W12b

A-4-MAL-20-0046

JULY 7, 2021

EXHIBITS

Project Plans – Sheet A-1.1 (Excerpt)

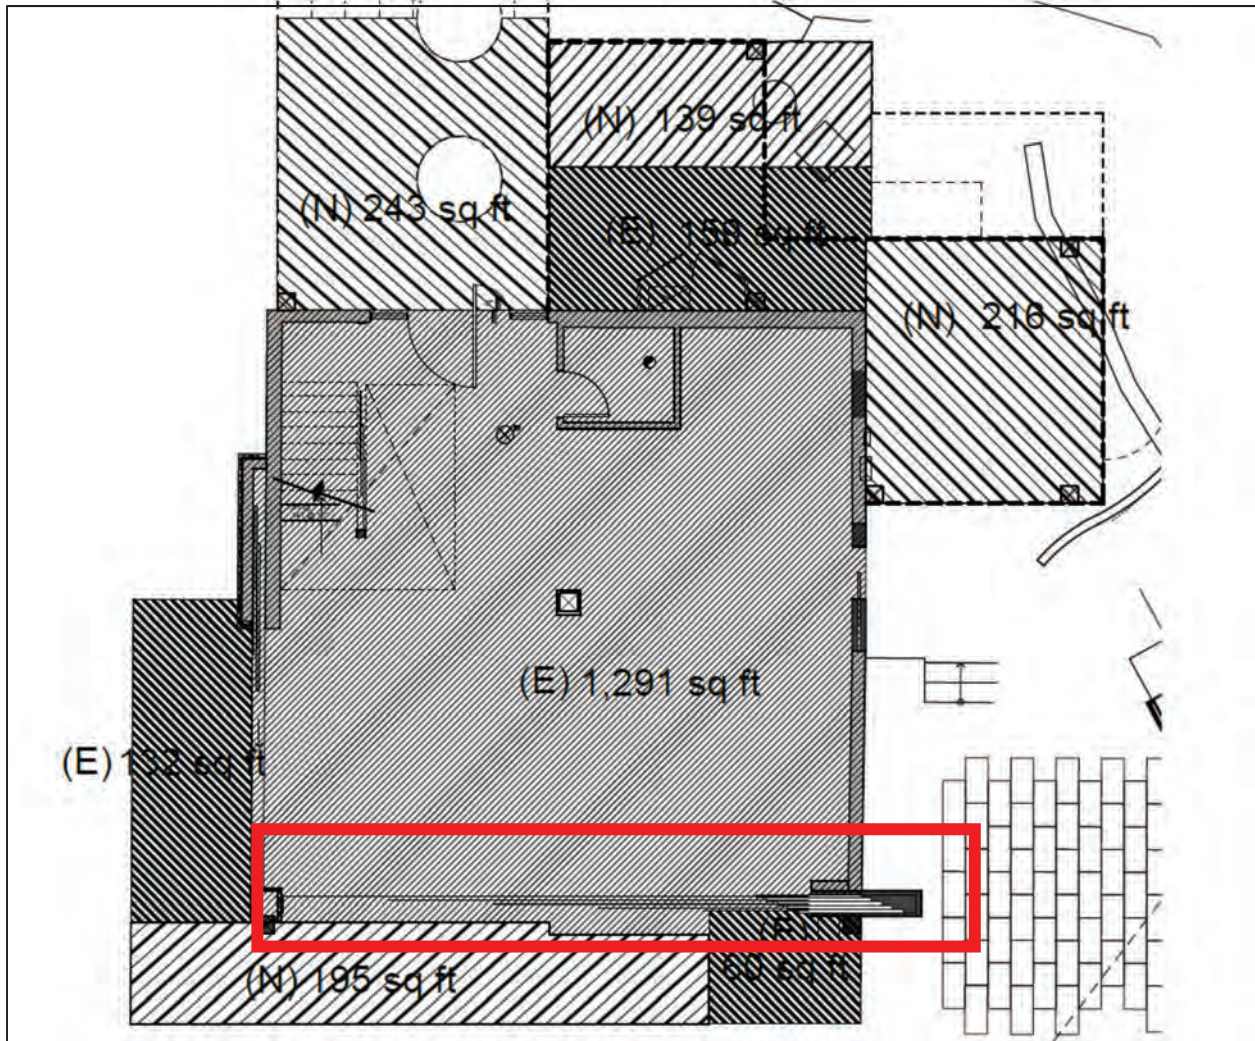
Spaces labeled (N) are covered porches that are being newly calculated as TDSF. The 195 square feet of seaward covered porch labeled as (N) is a currently existing porch that will be newly calculated in TDSF due to a replacing the fireplace located at the area boxed in red with a sliding pocket door.

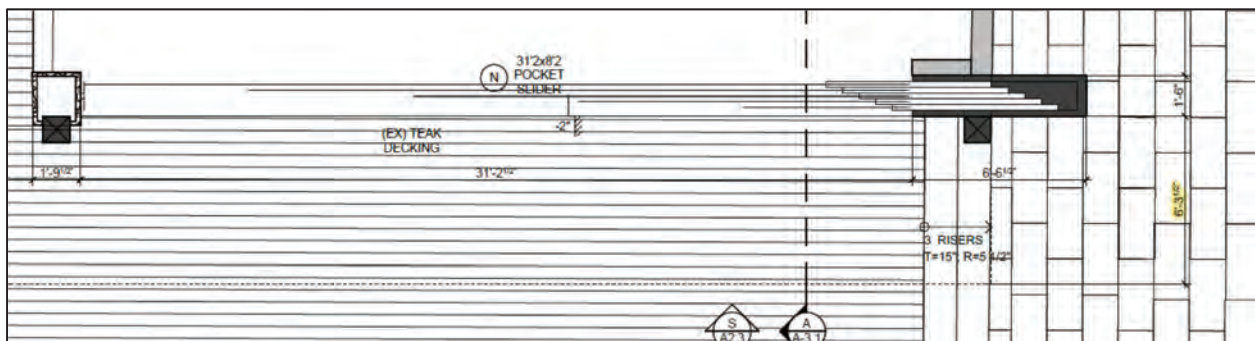
The below shows is a closer look at the red boxed area above. The depth is shown at the right (highlighted) as 6'3.5". This is increased from previous depth of 5'11".

MAIN EAST ELEVATION 2

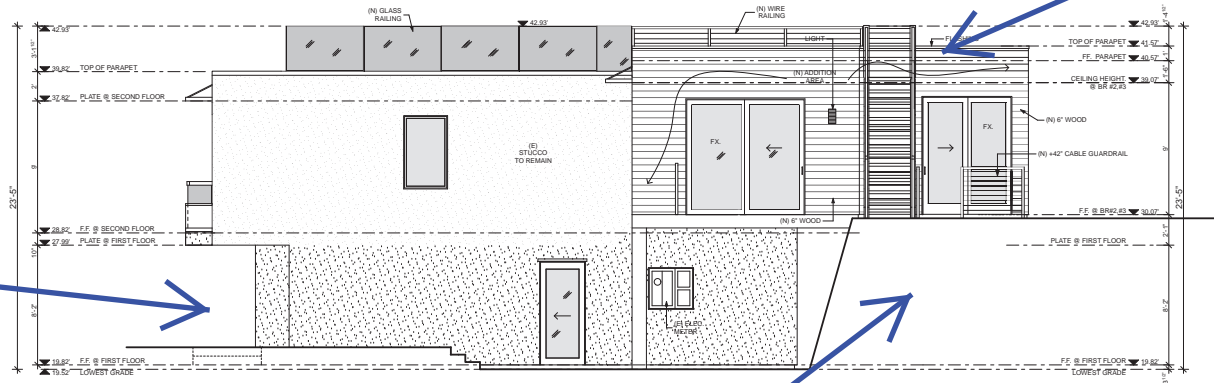
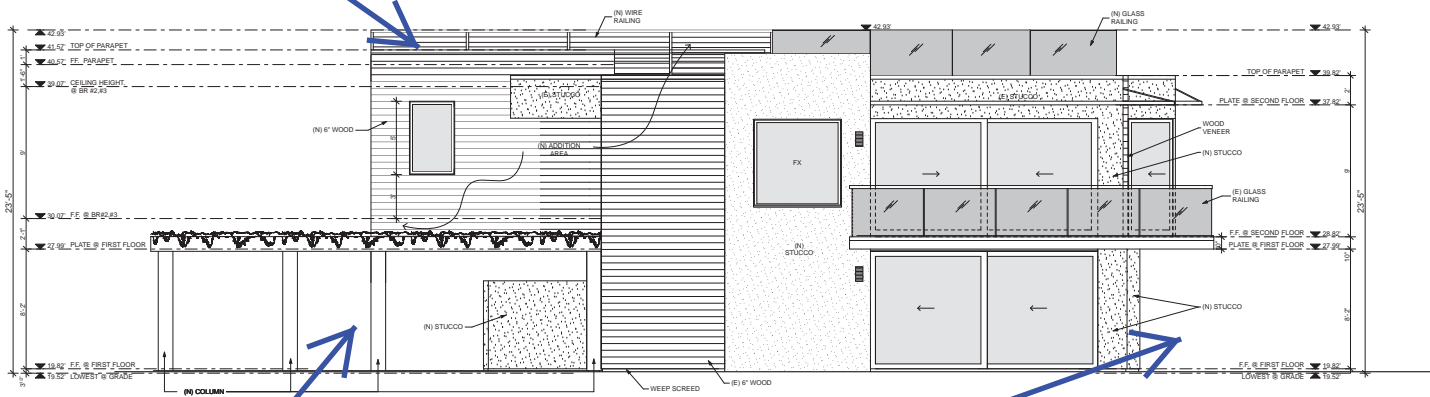
Existing covered porch that will be newly calculated in TDSF

Covered Porch Addition

Second Story Addition

Covered Porch Addition

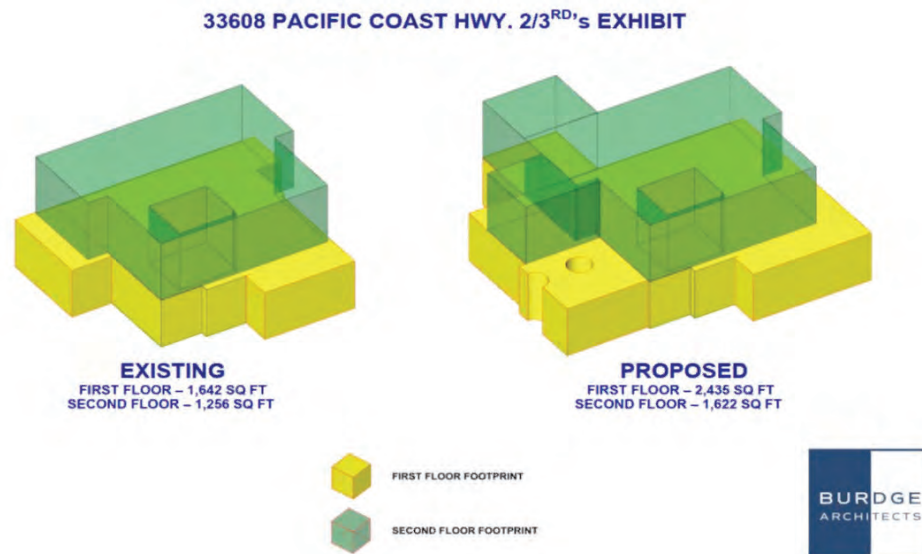
Here’s the existing house (center) and guest house (at left).¹⁹ Note that the second story is already the same size as the first. (The green pin shows ground level, with the covered pool set into the ground-level patio.)

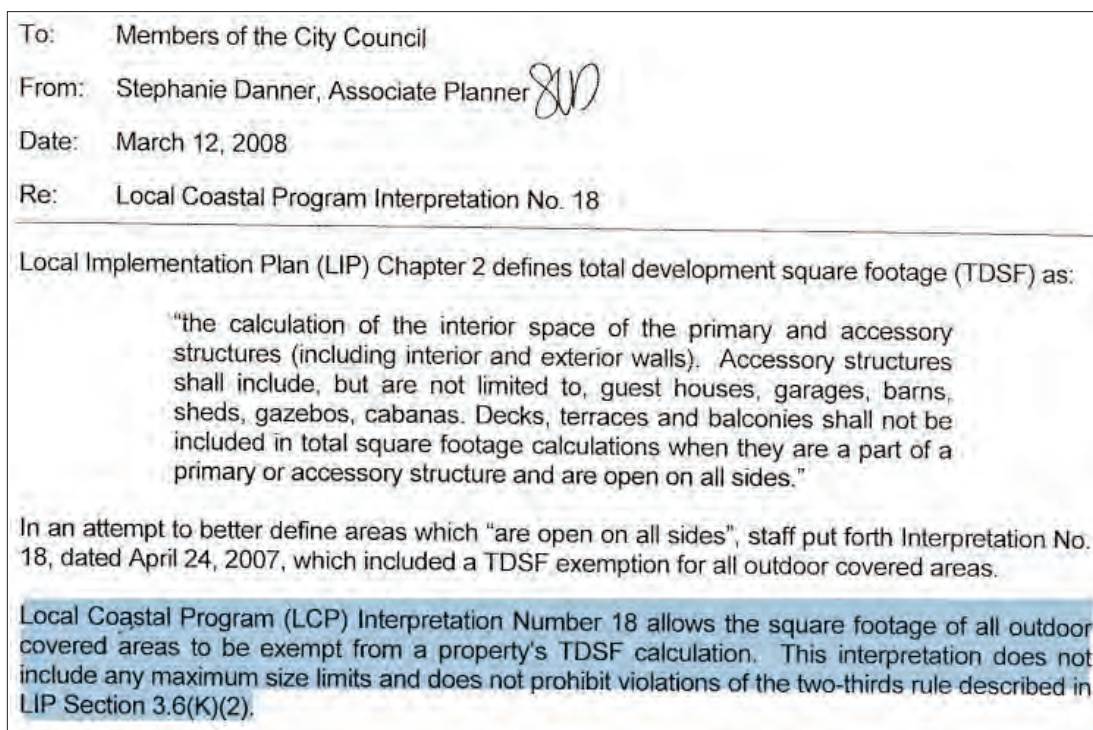
Underscoring that the 2/3 Rule was never formally subject to a new “interpretation” in 2008, the memo excerpt presented by Ms. Blue (above), when read in context, is more clearly just about TDSF calculations, not the 2/3 Rule. Following is a more extensive excerpt of the same memo, as it appears in the City’s Planning-Interpretations-and-Policies-Manual,²⁸ from which Ms. Blue copied selectively. The phrasing she began her excerpt with, “A new interpretation will be written...” is preceded by other material. Notice that in the first paragraph, staff has been directed to “begin work on” a ZTA – work which was never actually done, and which in any case is stated as being almost entirely about “new standards which exempt certain types of covered areas from the TDSF calculation.” The brief mention of the 2/3 Rule at the end appears almost as an afterthought, without any stated purpose other than “to prevent a box-like appearance” – which in itself doesn’t speak to how the “floor area” specified in the code should be measured. This expanded excerpt further confirms that the supposed “policy” cited by Council as being “in writing” was never actually written. Yet Council referred to a piece of wishful thinking as though it were already codified into law.

At the February 26, 2008 ZORACES meeting, staff brought its findings forward to the Subcommittee. At the conclusion of the meeting, the Subcommittee directed staff to retract Interpretation No. 18, create a revised interpretation based upon LIP Section 3.5.3(B)(1), and begin work on a Zoning Text Amendment (ZTA) to implement new standards which exempt certain types of covered area from the TDSF calculation.

A new interpretation will be written which will use this section of the LIP to allow covered areas up to six feet to be exempt from the TDSF calculation. If the covered area square footage exceeds the six foot projection, the entire covered area will be included in TDSF. Furthermore, the volume of the covered area will be included when calculating the two-thirds rule for a proposed structure in order to prevent a box-like appearance.
